GARD response to
Thames Water's Consultation on
Draft
Water Resource Management Plan 2024

21st March 2023

GARD response to consultation on Thames Water’s draft WRMP24

Figure 1 - London DYAA baseline supply demand balance

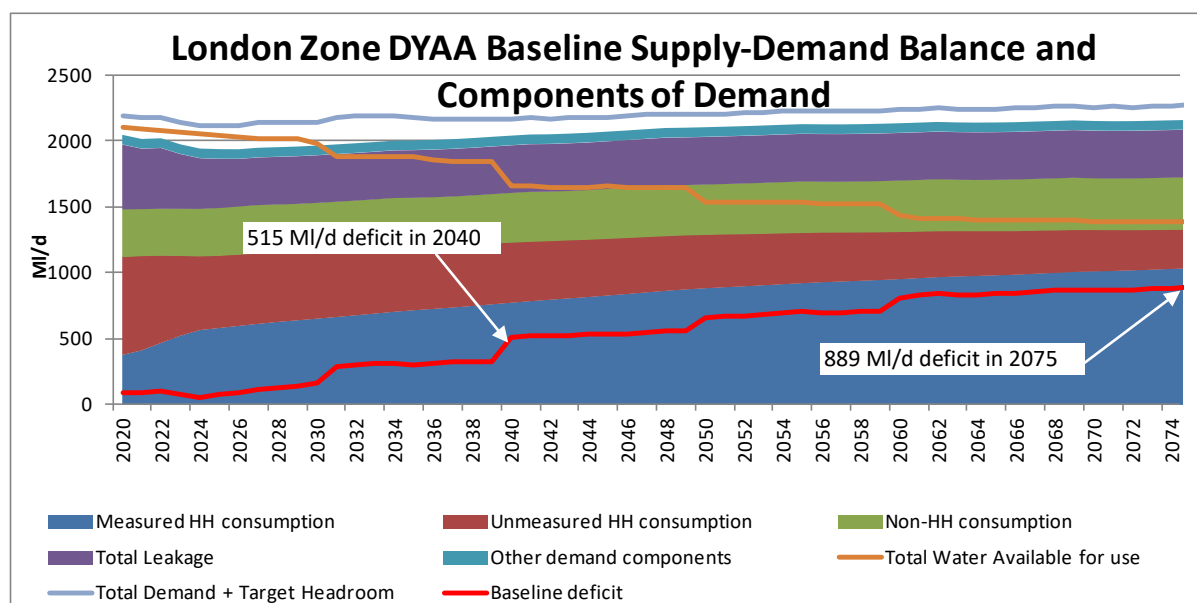
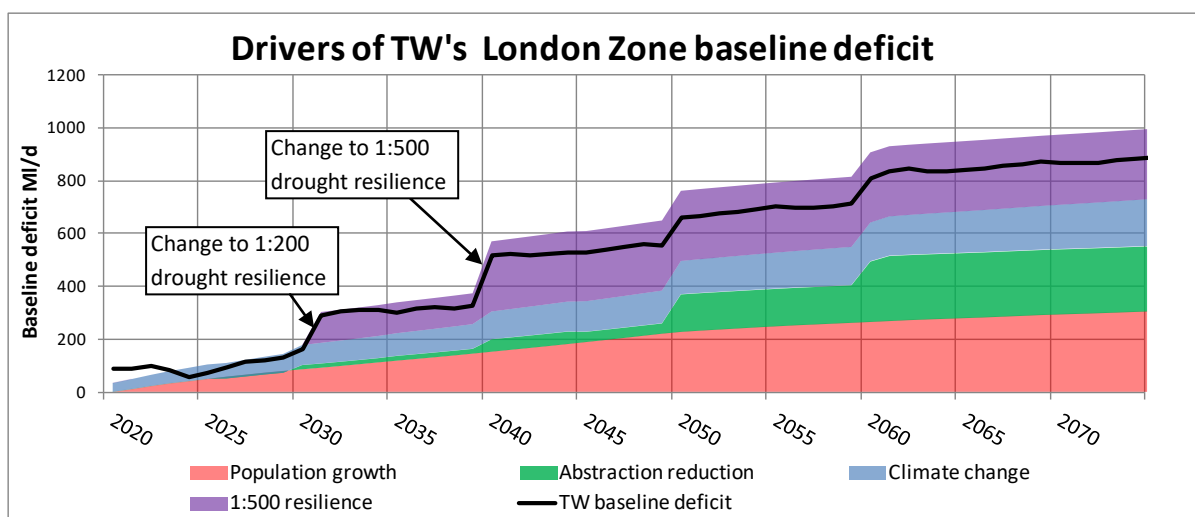
The baseline supply demand balance shows a deficit between supply and demand rising from 98 MI/d in 2022 to 889 MI/d by 1975. The deficits are over-stated by about 100 MI/d because, following Water Resource Planning Guidelines, they do not allow for the demand reductions due to Temporary Use Bans and Non-essential Use Bans which are part of current Levels of Service². The TUBs and NEUBs are included as measures in the Final Plan.

The main drivers of the London deficit total 571 MI/d by 2040 and 981 MI/d by 2075. These figures are somewhat more than the deficits shown on Figure 1 which total 515 MI/d by 2040 and 889 MI/d by 2075. The reason for the difference is that the baseline deficits allow for leakage and PCC reductions which are being implemented in the current AMP7 business plan.

Figure 7 - Population growth assumed in TW's preferred plan

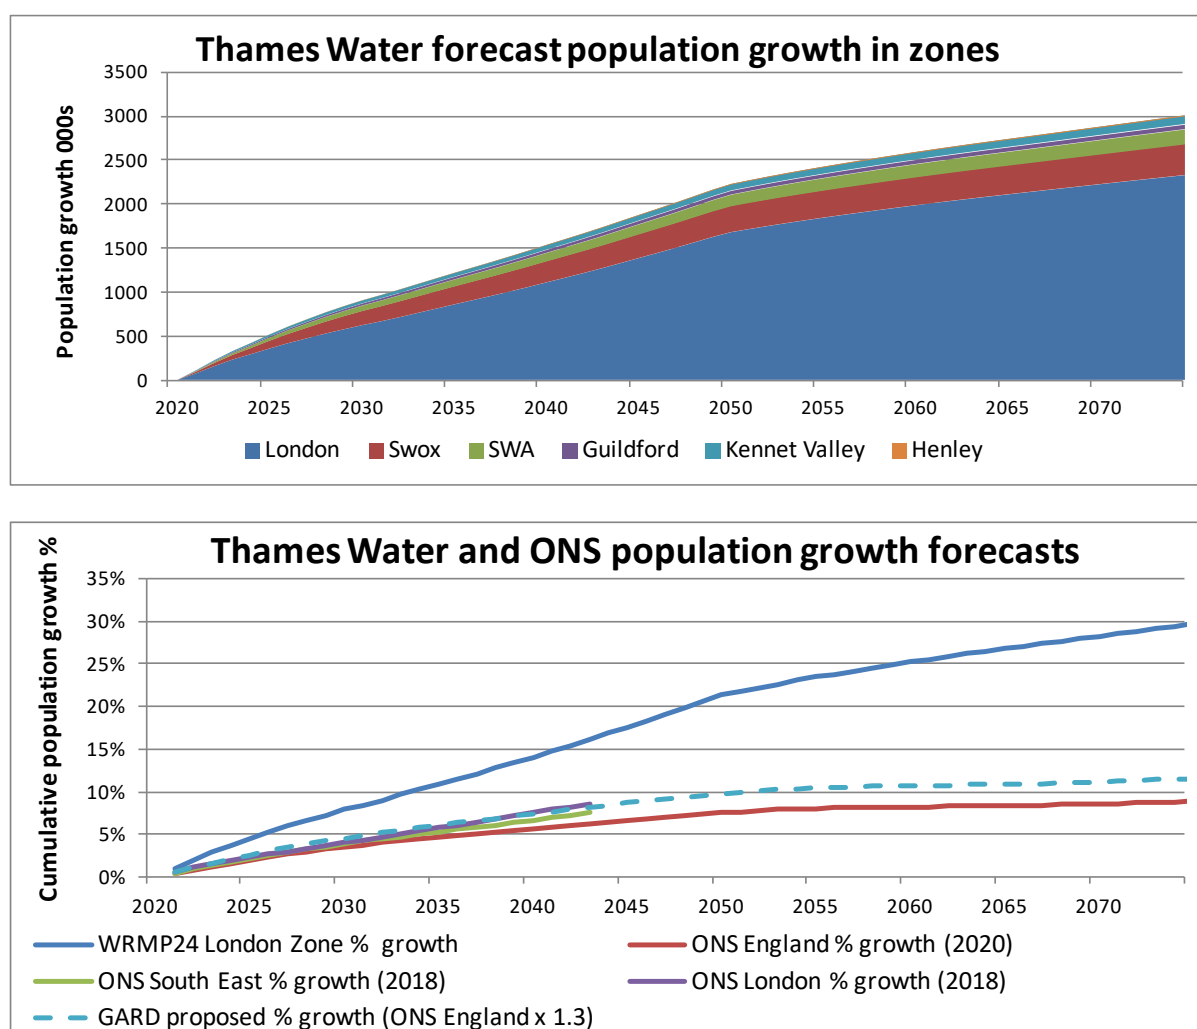
This shows population growth rates that are far in excess of ONS forecasts. Paragraph 3.78

Figure 9 - Deployable output loss due to climate change in each zone

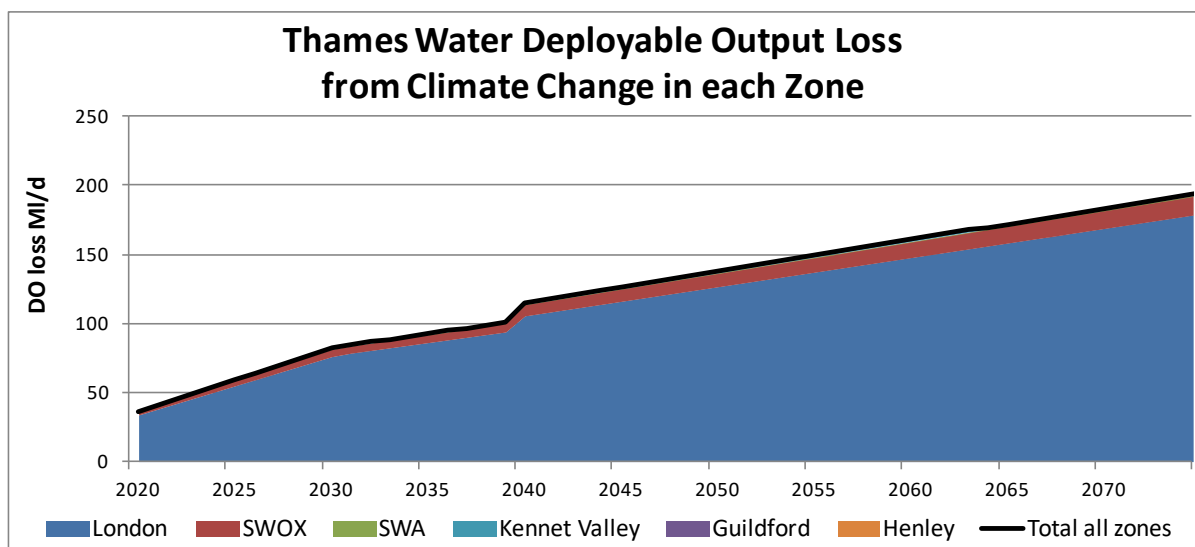
Figure 9 shows that that most of this loss is in Thames Water's London region, with smaller losses in SWOX zone. These are zones with surface water resources and reservoirs.

The preferred plan assumes that the deployable output of London supplies has already been reduced by 46 MI/d in 2023 (see Figure 9). In our opinion, this defies the evidence set out in Section 2.4.2 that there has to date been no adverse impact of climate change on London’s supplies and, probably, a significant increase in deployable output. Therefore, we propose

Figure 11 - Seasonal rainfall trends in England and Wales, since 1760

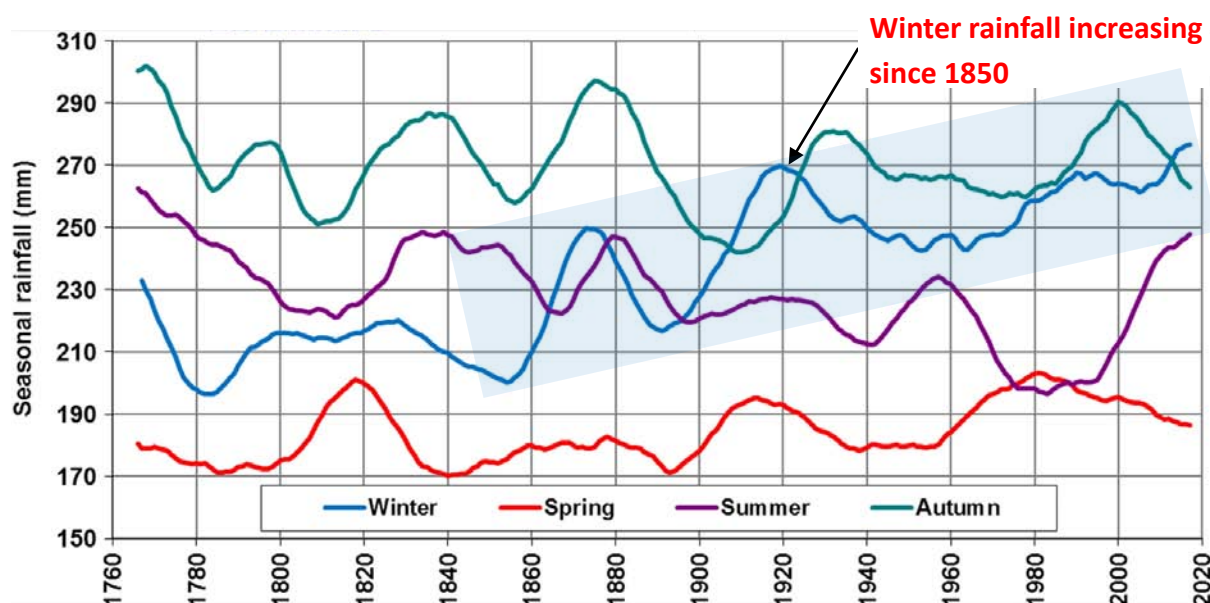
The increasing trend in winter rainfall improves the drought resilience of London's supplies, because the winter rain is stored in the chalk aquifer and released slowly through the summer. The falling trend in summer rainfall, as shown in Figure 11, has less of an impact on London's supplies, because most of the summer rain is absorbed by evapo-transpiration or

Figure 14 - Target headroom allowances in each zone

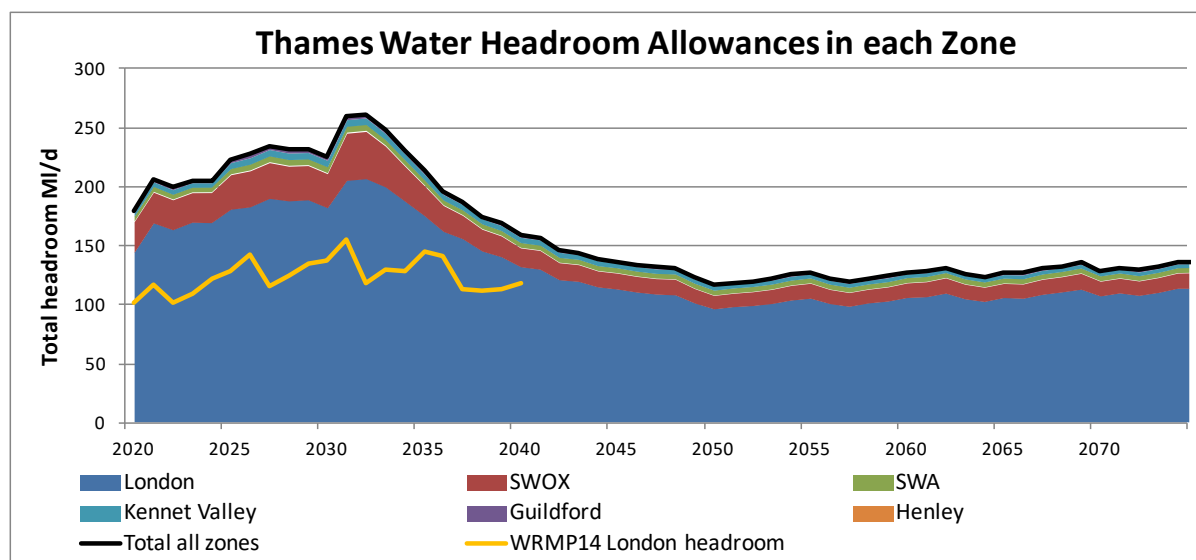
Figure 14 shows the large headroom allowances in the London and SWOX zones, corresponding to about 8% of present deployable output.

Figure 14 also shows the London zone headroom allowance in Thames Water WRMP in 2014³⁵. This allowance was mostly about 50 MI/d less than the latest London zone headroom. Moreover, WRMP14 only provided for the 'worst historic' drought, with the possibility of a drought more severe than historic allowed for in the headroom. This was probably the most important component of the headroom prior to adoption of the 1:500 year resilience standard. However, now that the resilience standard has been raised to 1 in 500 years, there is little need for headroom to accommodate the possibility of even more severe droughts.

Figure 15 - GARD proposed revision to London baseline deficit drivers

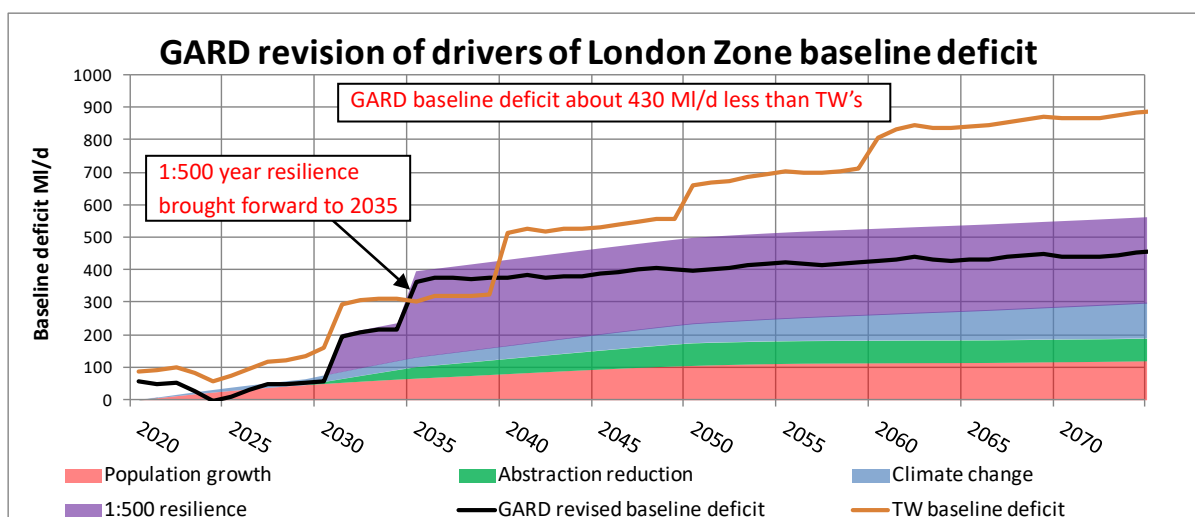
Taking account of GARD's comments on population growth, environmental reductions and climate change, the drivers of the London baseline deficit would be as shown in Figure 15:

Figure 16 - GARD proposed revision to SWOX baseline deficit drivers

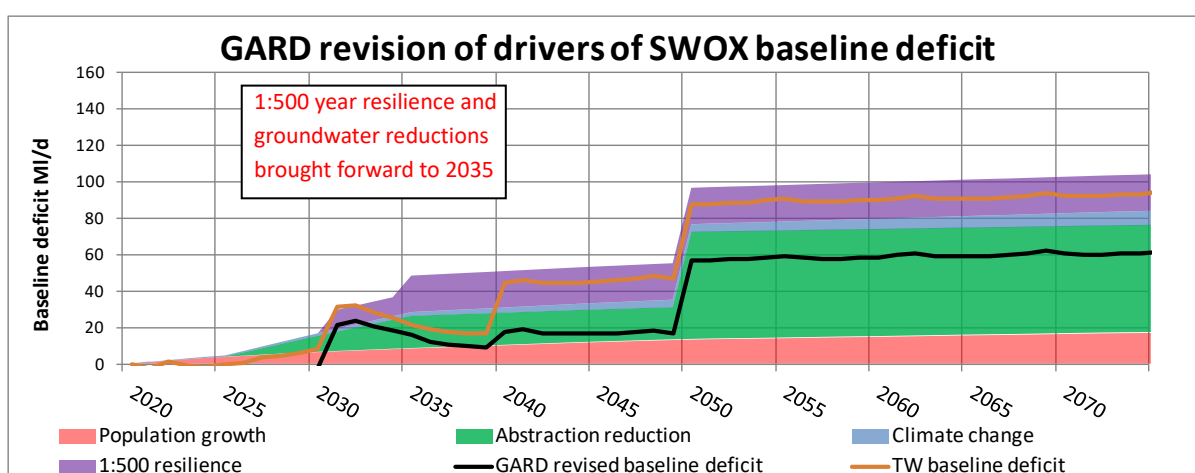
GARD's revision of the drivers of the SWOX baseline deficit would be as shown in Figure 16:

Figure 17 - GARD proposed revision to Thames Valley baseline deficit drivers

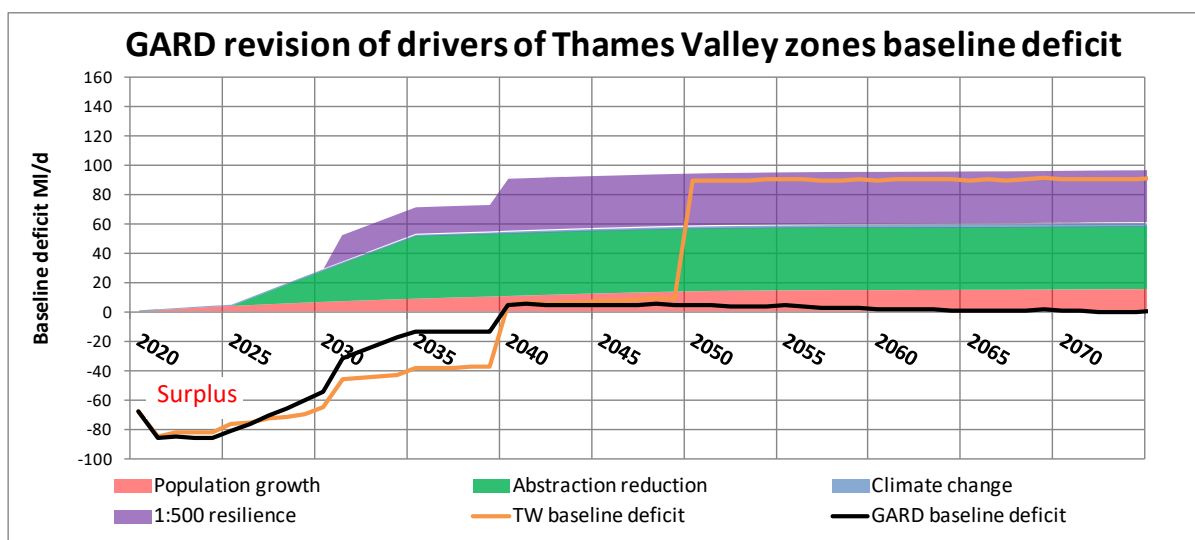
GARD's reassessment shows that no new resources are needed for the Thames valley zones, even with the planned abstraction reductions in the Wey, Enbourne and Misbourne brought forward to 2025-35, as shown in Figure 17.

Figure 19 - Comparison of TW and United Utilities planned urban PCC reductions

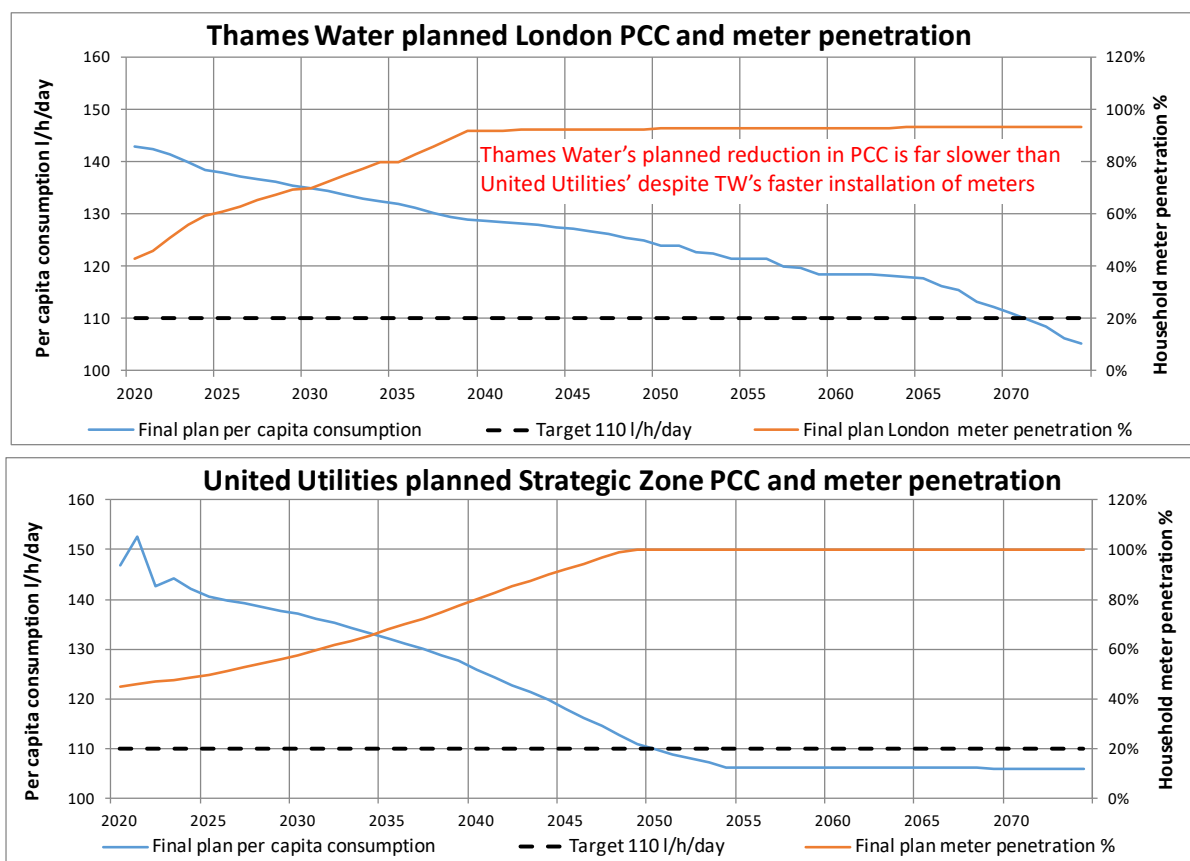
Figure 19 shows a large disparity in the planned achievement of the 110 l/person/day target despite the similarity of the zones in terms of size and urbanisation. United Utilities plan to meet the target by 2050, whereas Thames Water's London PCC is still at 124 l/person/day in 2050, despite planned meter penetration of 90% by 2040.

Figure 20 - Thames Water's planned meter penetration in each zone

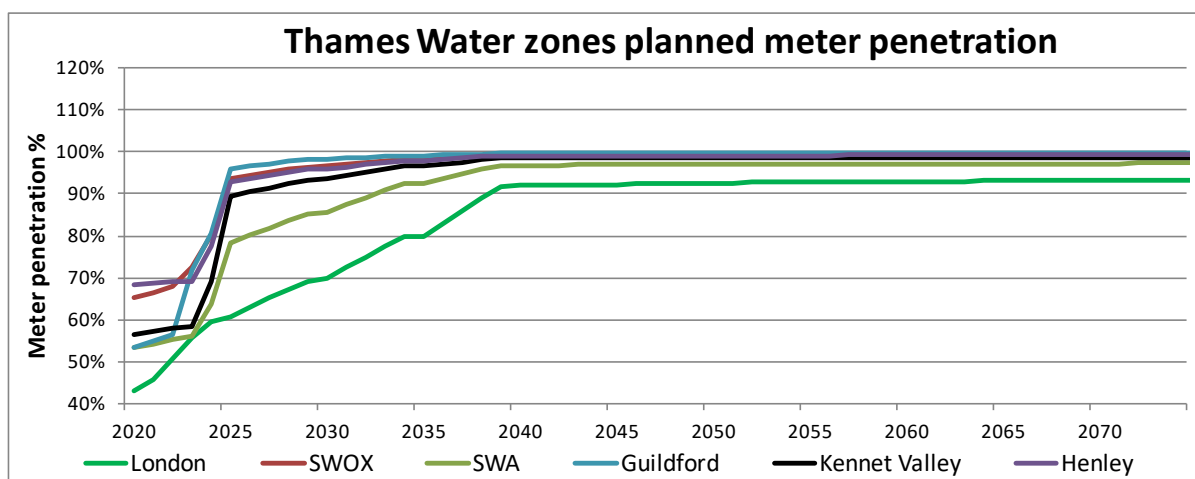
This shows that Thames Water plan near total meter coverage in all zones by 2040, so the forecast failure to meet the 110 l/p/day target by 2050 seems unduly pessimistic. If TW say the target can be met in every zone by 2075, as shown in Figure 18, why can't this be achieved by 2050?

Figure 22 - Compliance with 50% leakage reduction target by zone

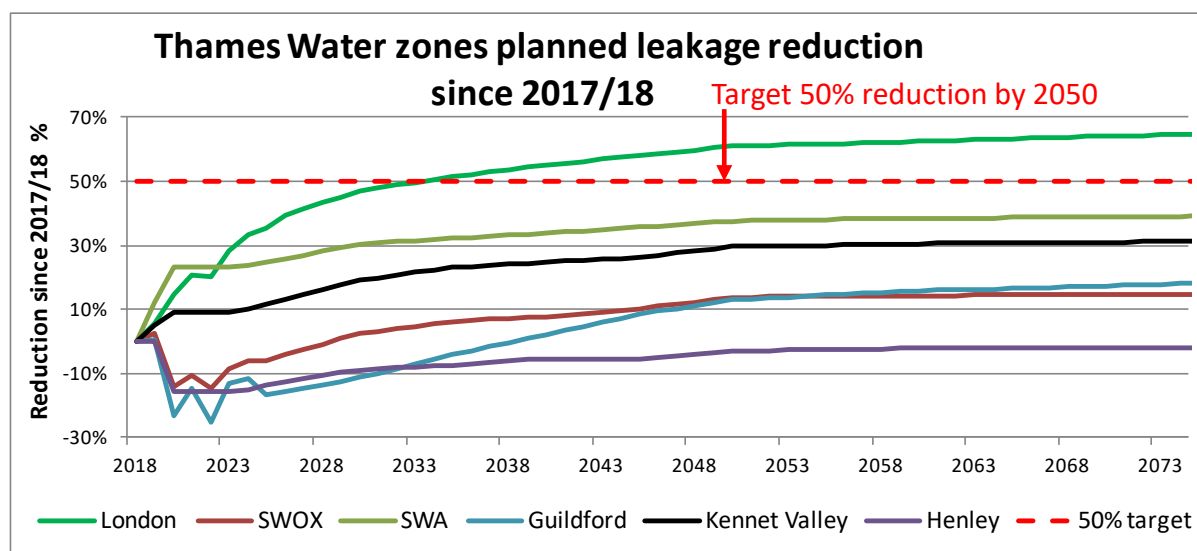
Most of the planned leakage reductions are in London, where the planned gross leakage reduction is from 566 MI/d in 2017-18 to 225 MI/d in 2050, a reduction of 60% and well ahead of the Government's 50% reduction target. GARD welcomes this and notes that the planned leakage of 53 l/property/day in 2050 is slightly less than United Utilities' planned 56 l/property/day in their similarly urban Strategic Zone.

Figure 26 - Typical operational use of the 120 MI/d Thames to Southern transfer

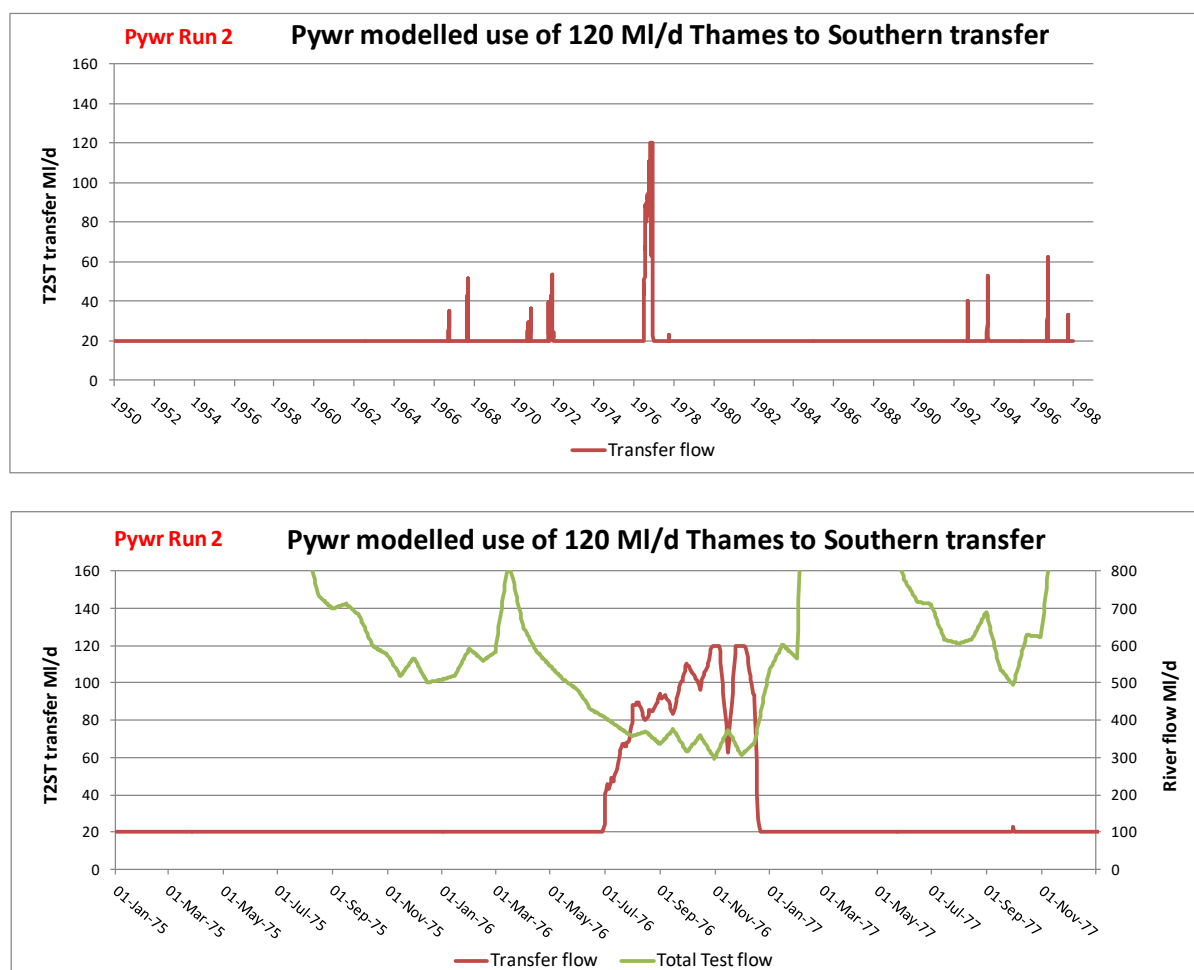
In major drought years, like 1976 in the example shown in the lower plot in Figure 26, the transfer could run for 6 months or more, triggered to comply with a total Test hands-off flow of 355 MI/d, and peaking at the 120 MI/d capacity for short periods. However, although the Pywr modelling shows drought use about once in 5 years on average, usually this will be for a relatively short period and at much less than the 120 MI/d capacity.
